**Re: Comment on Sustainable Communities Environmental Assessment (SCEA)
Lucia Park Project (620 N. Brand Boulevard and 625 N. Maryland Avenue)**

Responses to Comments
Comment Letter No. 1

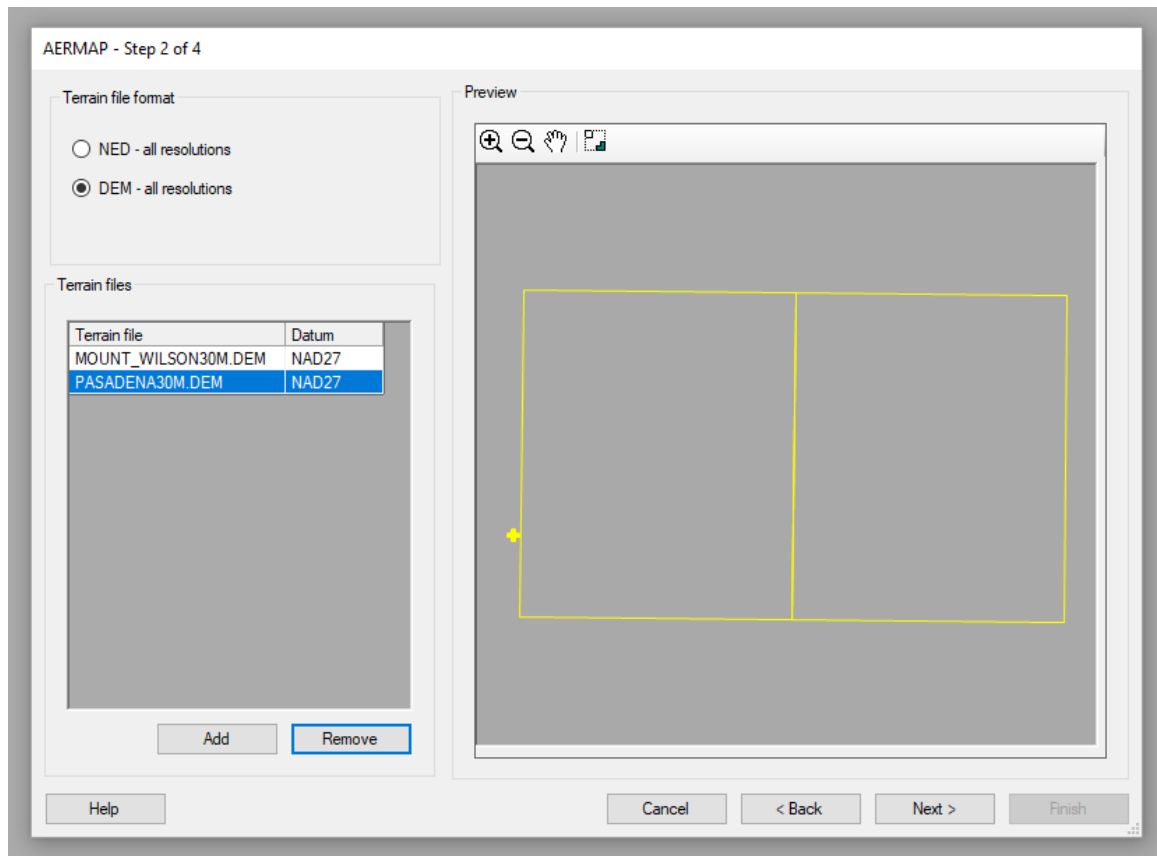
AERMOD program.”⁴⁷ As Dr. Clark points out in his comments, AERMOD does not have a component that stores 7.5-minute quadrangles. Quadrangles can be obtained through the California Air Resources Board’s (“CARB”) HARP Digital Elevation Model Files.⁴⁸

Despite this error, Dr. Clark was able to download comparable Pasadena and Mt. Wilson DEMs and upload them to the AERMOD model. Upon uploading the DEMs, Dr. Clark found that neither of the DEMs were useful because no sources for the model were associated with either DEM rendering them useless for analysis of the Project.⁴⁹

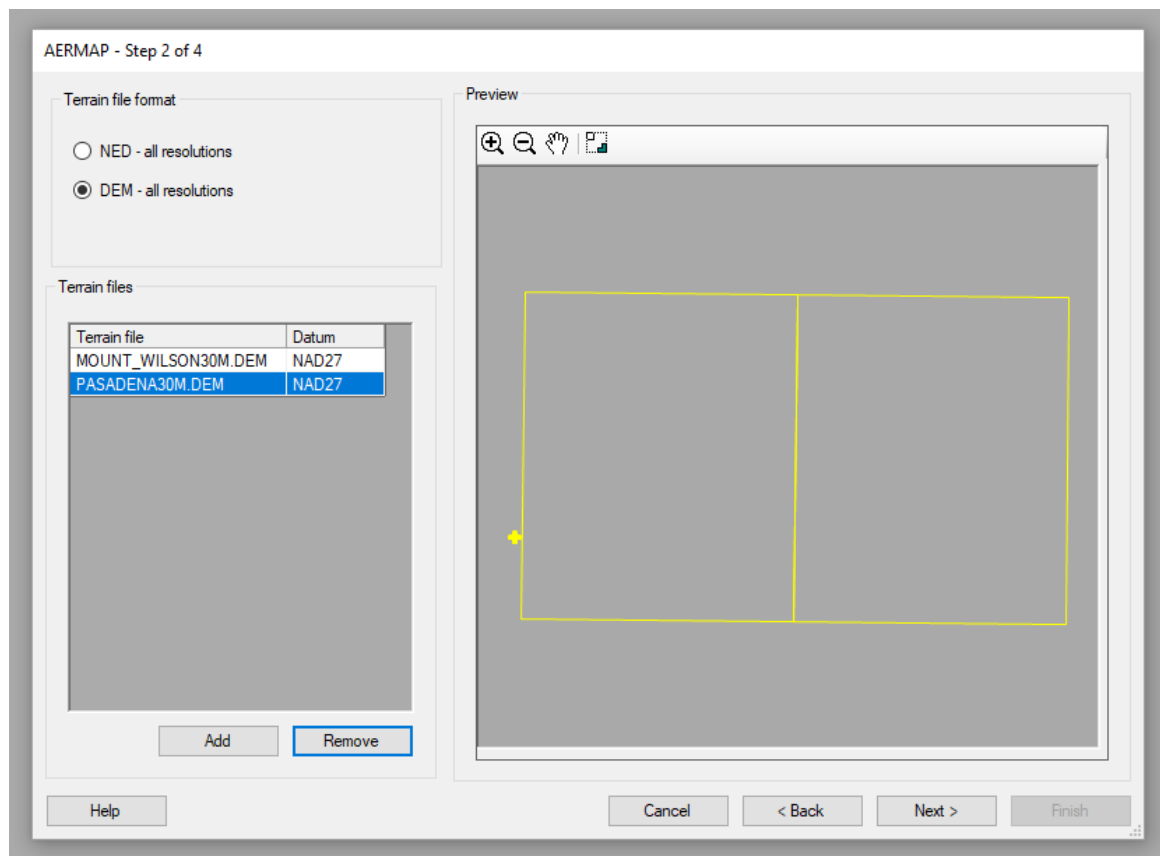
Under the section of Appendix B labeled Terrain Data on page 20 of 39, the City describes the use of “digital elevation model (DEM) data for the Pasadena and Mount Wilson 7.5-minute quadrangles obtained through the AERMOD program.” AERMOD does not have a component that stores 7.5-minute quadrangles. Quadrangles can be obtained through the California Air Resources Board’s (CARB) HARP Digital Elevation Model Files (ww2.arb.ca.gov/resources/documents/harp-digital-elevation-model-files). After downloading the Pasadena and Mt. Wilson DEMs and uploading them to the AERMOD model, neither the Pasadena Quadrangle DEM or the Mt. Wilson DEM are useful in the model domain. The Pasadena DEM is to the east of the receptors for the Project location. The Mt. Wilson DEM is to the east of the Pasadena DEM and no sources for the model were associated with that DEM.

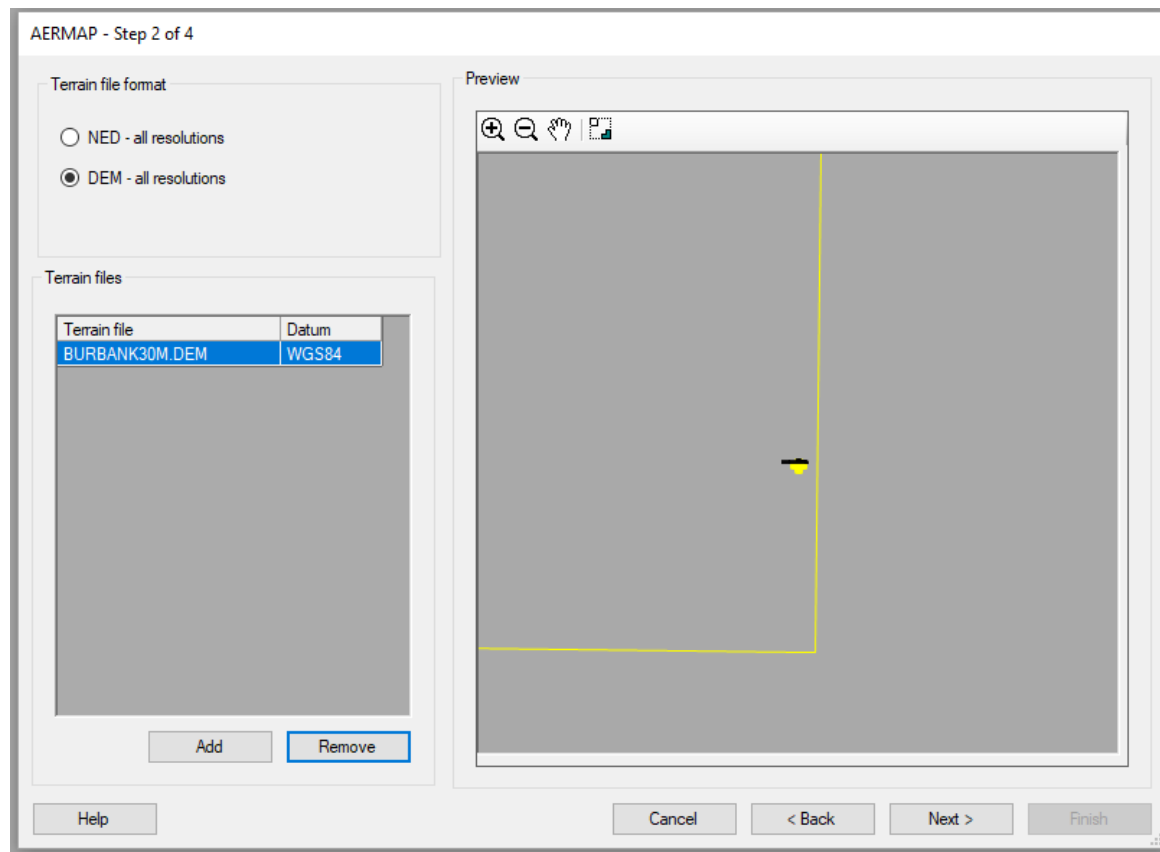
The only DEM required in the model is the Burbank DEM. No receptors are identified as being present in the Pasadena or Mt. Wilson DEMs.

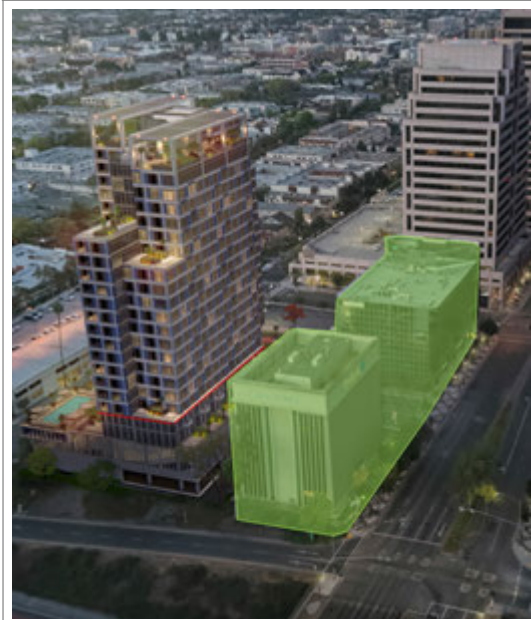
The proposed building at 24 stories would not “step down” as described to align with the existing cornices (see Figure 6). A string course or “a horizontal band... in a building forming a part of the design” is not a step, except on three bays at the slim north side which notably faces the freeway (*Merriam-Webster.com Dictionary*, Merriam-Webster, <https://www.merriam-webster.com/dictionary/stringcourse>. Accessed 9 Jan. 2022). In the section entitled “Building Design: Massing and Scale,” the Downtown Specific Plan directs in a diagram that “High rise massing should be divided to reduce overall bulk and step graciously down towards lower adjacent structures” (page 4-11). We see little stepping and no demonstrated evidence of design courtesy or deference toward the existing, low-rise historic resources.

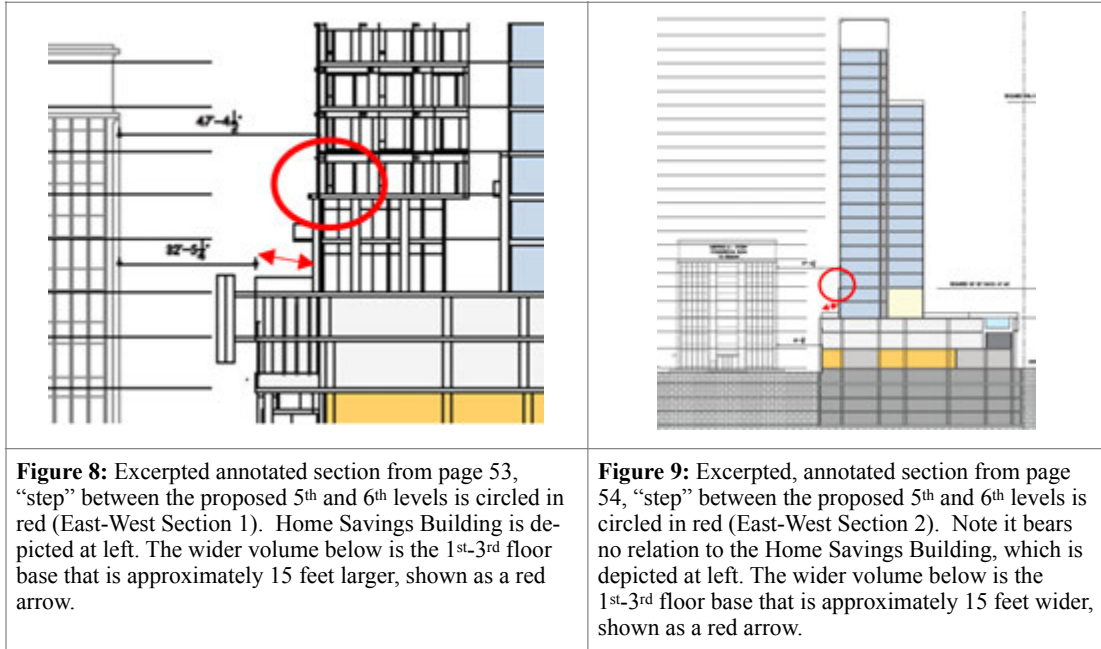
Additional details of the proposed “step” in the proposed project In Figures 8 and 9, and on pages 53, 56 and 57 of Exhibit 1, Stage II Final Design Review Packet reveal that the step it is no more than a difference in materials, applied at the same depths, embellished by a horizontal band. The proposed step is more window dressing than a demonstrable difference in dimension.

What review of the design packet reveals is that the proposed project steps “away” from the Home Savings Building by fewer than 15 feet, which is less than the length of standard parking spaces (red arrows, Figures 8 and 9). What the proposed project would actually “step back” from are the low-rise buildings on the east side of Maryland Avenue, by 20 feet (just 2 feet longer than a standard parking space).

Figure 2: Excerpt from north elevation of [previously] proposed project. Annotation shows historic resource in yellow, with less than a window bay's width separating the over-scaled new tower, and its 9-11th floors overhanging the historic property at the red arrow.

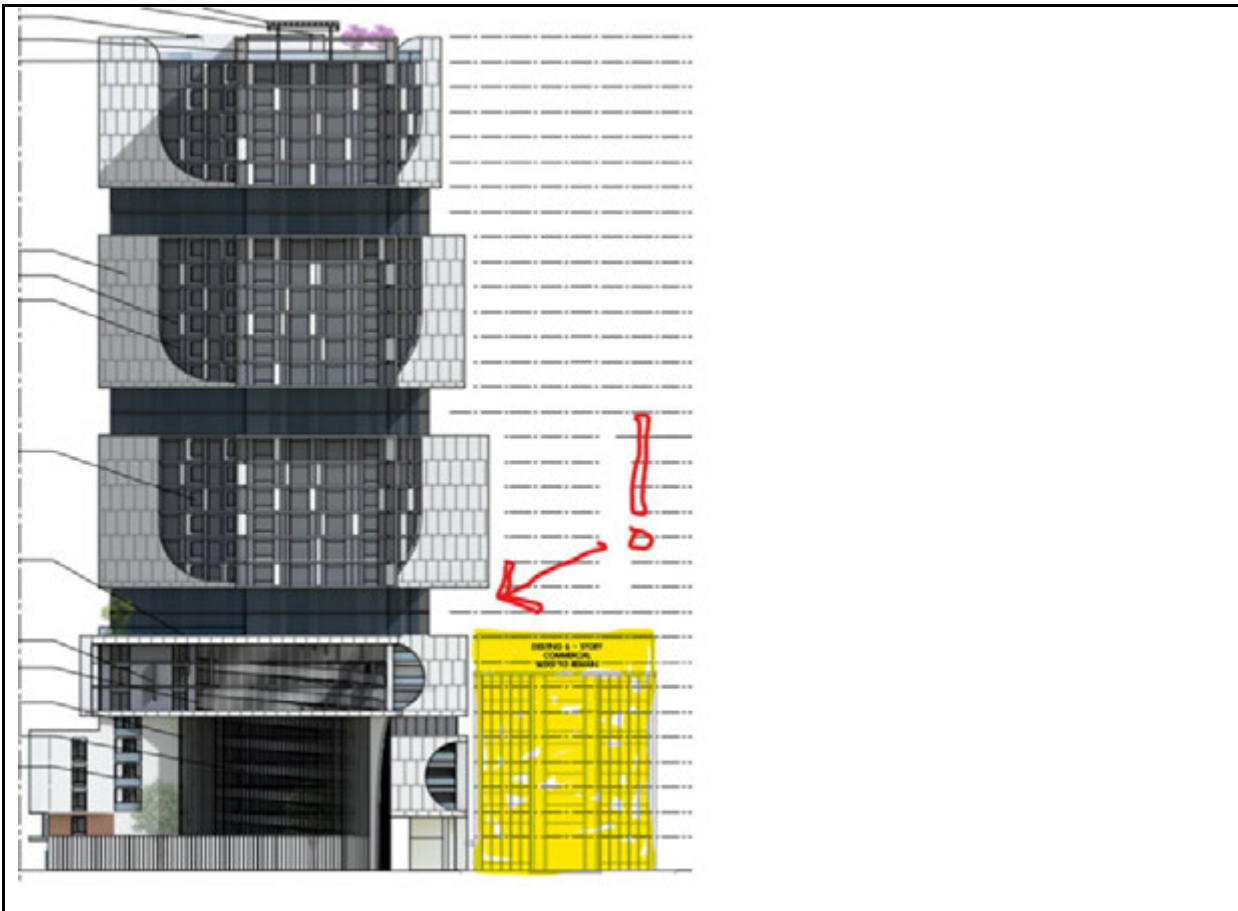
The historic tower would only be visible from the west as currently designed. The proposed project as designed is too close, and would loom over the main building (see Figure 2).

Figure 3: Excerpt from East Elevation, page 57. Note the parsimonious difference in heights on the left and right three bays. Source: Lucia Park 625 Maryland Ave, Glendale CA Stage II Design Review by John Freidman Alice Kimm Architects, 2019, not for publication (Lucia Park).

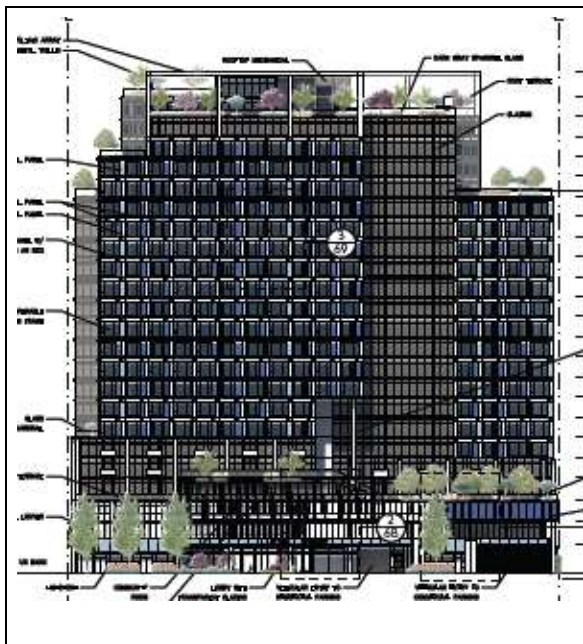
We also note that the proposed differences in color on the exterior of a high-rise, which is generally a difficult long-term maintenance choice, does not provide the necessary articulation. The proposed busy color scheme would provide some animation at an unnecessary long-term cost, but not the necessary articulation of massing required. Note that the differences in color are nearly lost at the scale depicted in the figures below.

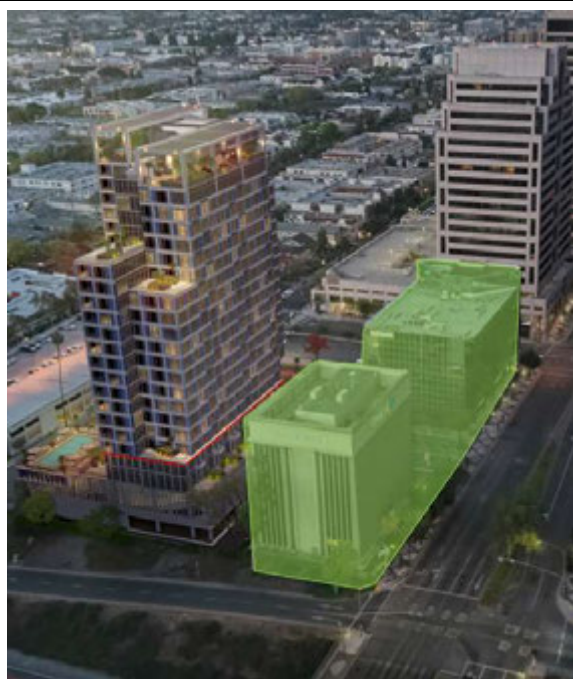
The proposed building at 24 stories would not “step down” as described to align with the existing cornices (see Figure 6). A string course or “a horizontal band... in a building forming a part of the design” is not a step, except on three bays at the slim north side which notably faces the freeway (*Merriam-Webster.com Dictionary*, Merriam-Webster, <https://www.merriam-webster.com/dictionary/stringcourse>. Accessed 9 Jan. 2022). In the section entitled “Building Design: Massing and Scale,” the Downtown Specific Plan directs in a diagram that “High rise massing should be divided to reduce overall bulk and step gracefully down towards lower adjacent structures” (page 4-11). We see little stepping and no demonstrated evidence of design courtesy or deference toward the existing, low-rise historic resources.

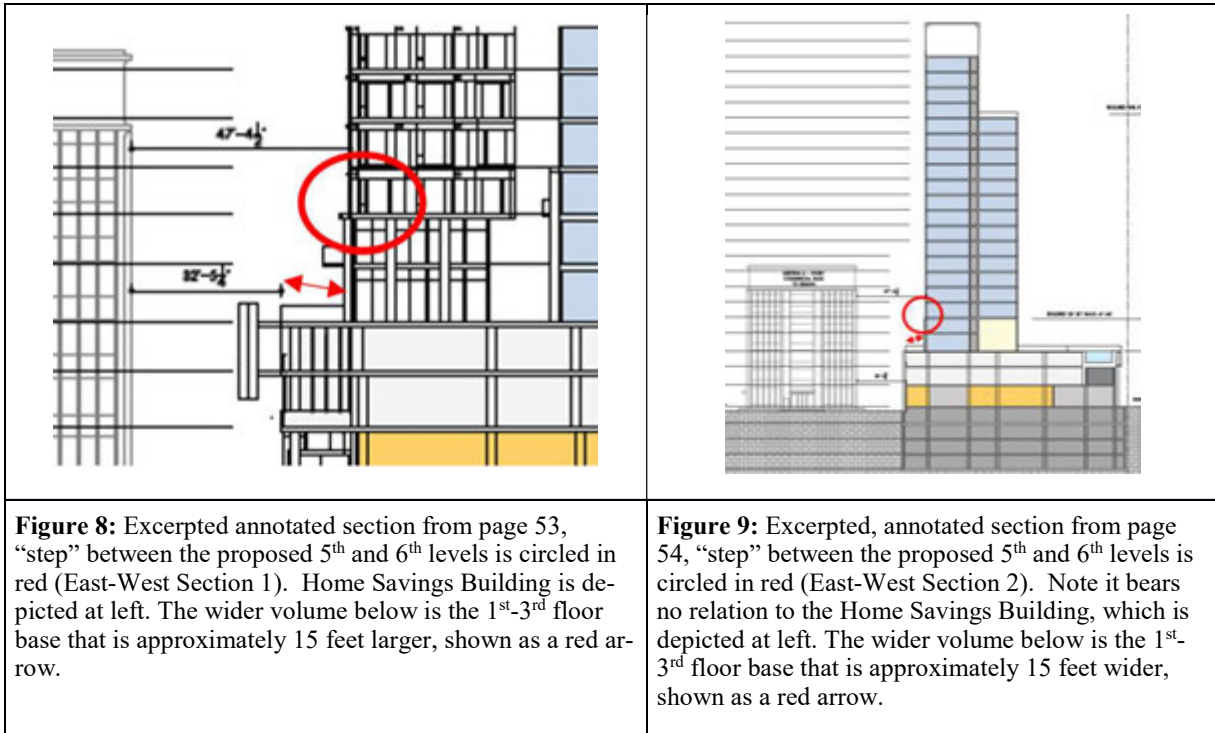
Additional details of the proposed “step” in the proposed project In Figures 8 and 9, and on pages 53, 56 and 57 of Exhibit 1, Stage II Final Design Review Packet reveal that the step it is no more than a difference in materials, applied at the same depths, embellished by a horizontal band. The proposed step is more window dressing than a demonstrable difference in dimension.

What review of the design packet reveals is that the proposed project steps “away” from the Home Savings Building by fewer than 15 feet, which is less than the length of standard parking spaces (red arrows, Figures 8 and 9). What the proposed project would actually “step back” from are the low-rise buildings on the east side of Maryland Avenue, by 20 feet (just 2 feet longer than a standard parking space).

FIGURE 1-1
VICINITY MAP

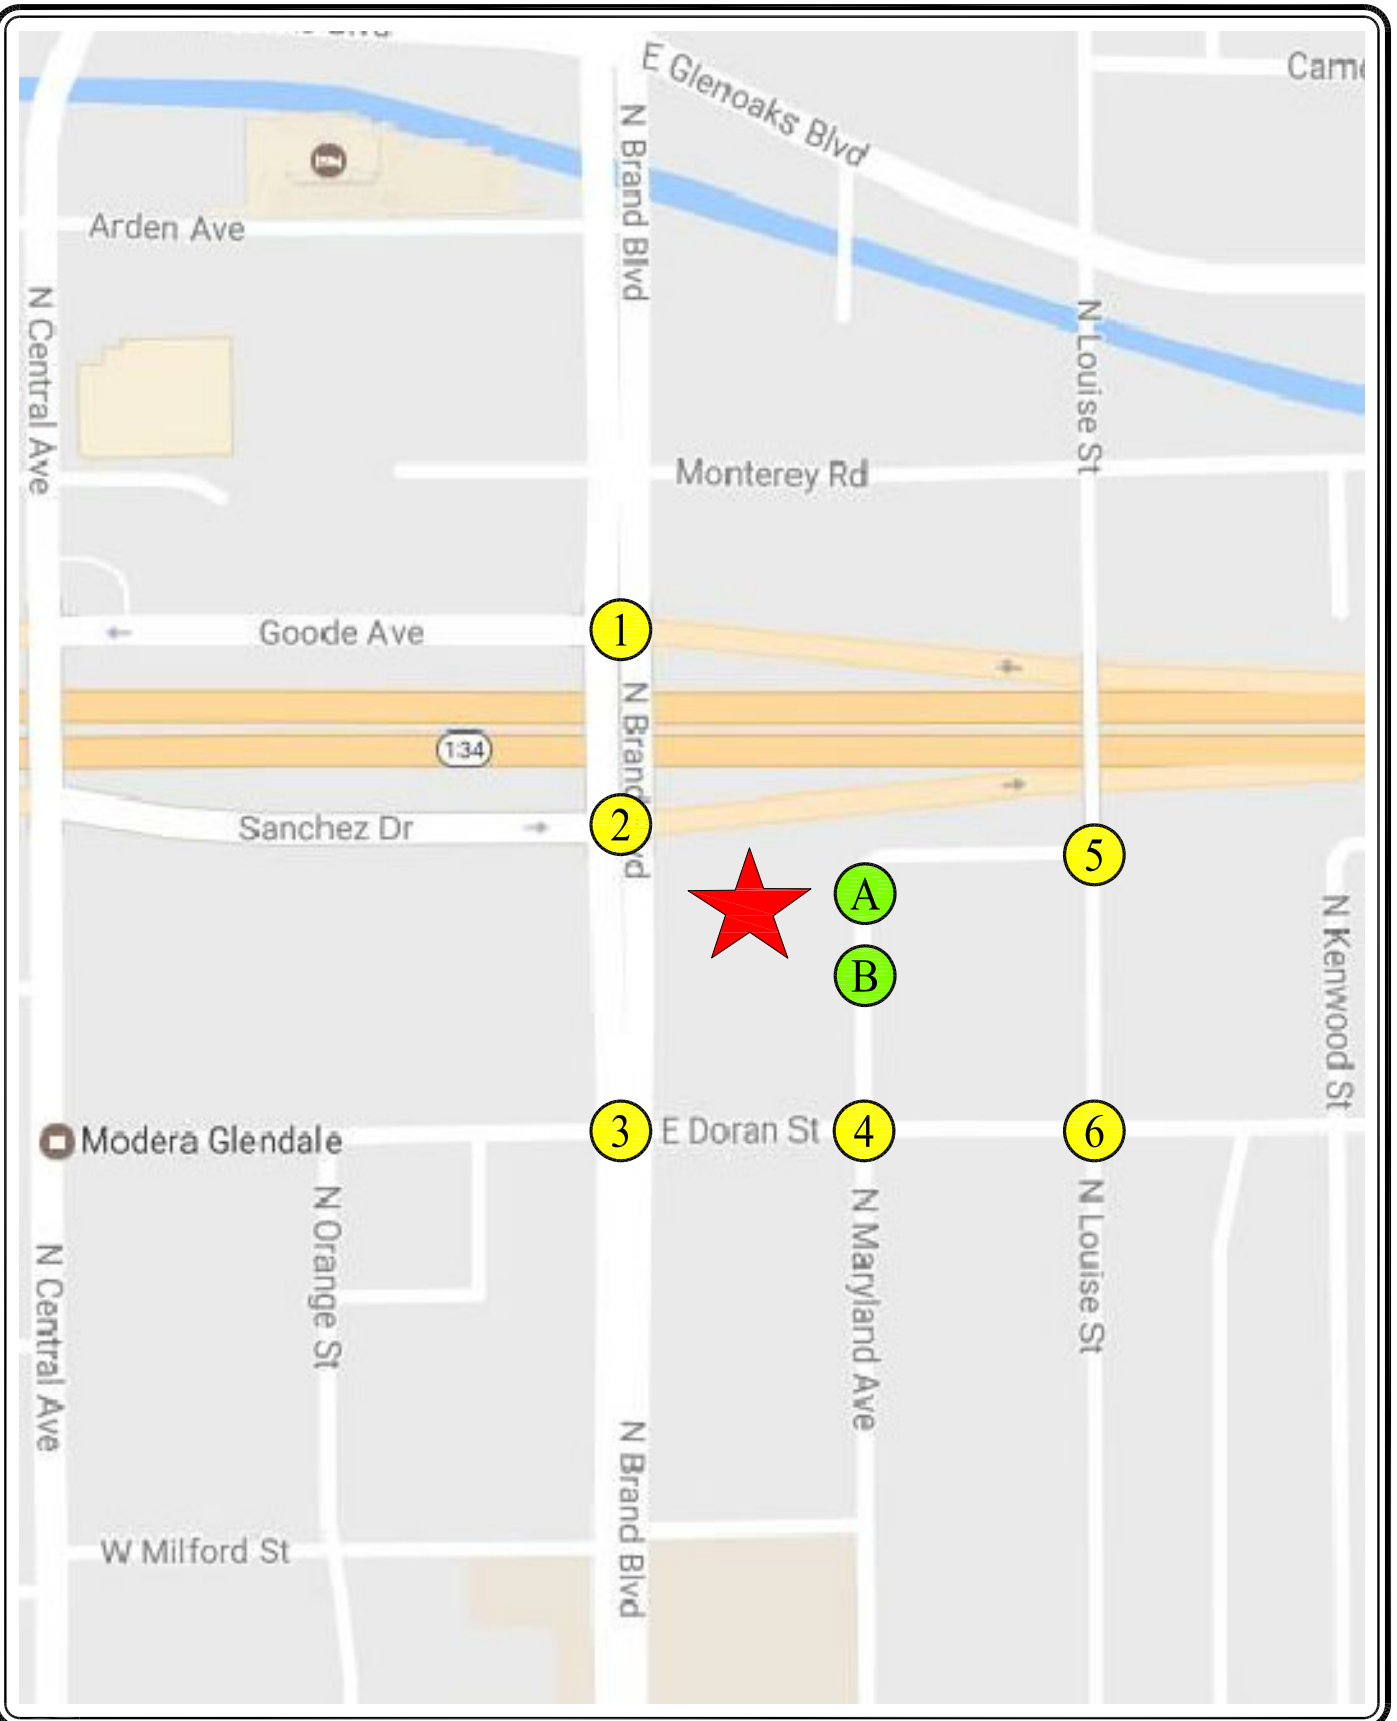
Figure 1-1 (Vicinity Map) – Please provide entrance points to the Project.

The comment asks to provide entrance points to the Project on Figure 1-1 of the TIA. Updated Figure 1-1 depicting the vehicular access points to the Project is attached to **Appendix B**.

An updated Figure 1-1 (Vicinity Map) depicting the Project's vehicular access points is attached to this memorandum.
